# FINAL DRAINAGE REPORT

## DEYOUNG SUBDIVISION BENT GRASS MEADOWS DRIVE

### Engineering Review

EPC Planning & Community  
Development Department

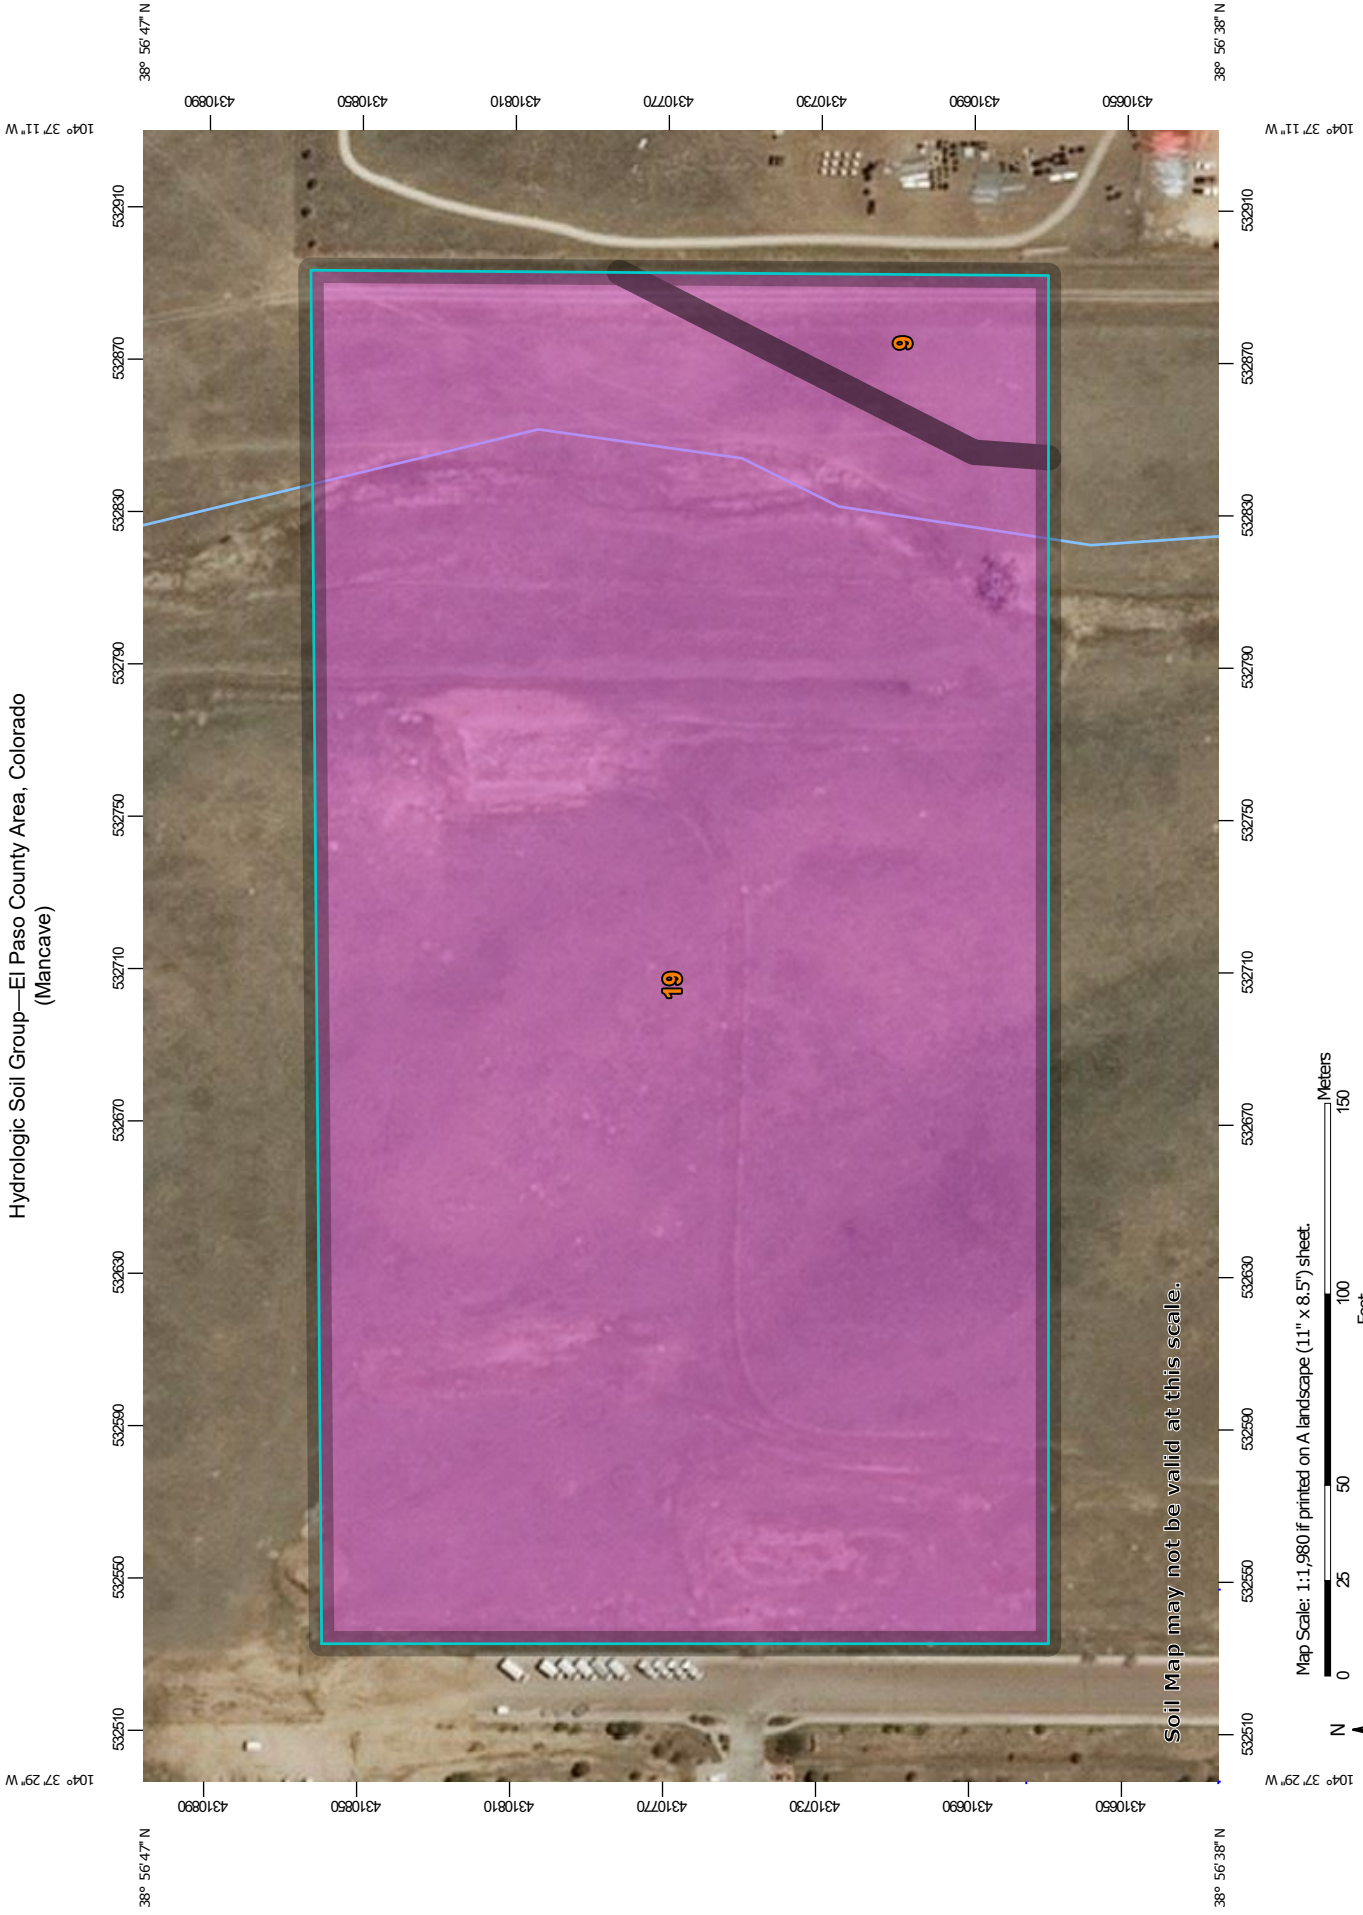
The required drainage and bridge fees are calculated as follows: Subtract tract area.

*Note: Handwritten blue annotations include a cloud-like shape around the unit prices and arrows pointing to the 'Subtract tract area' text and the 'Net Impervious Area' value.*
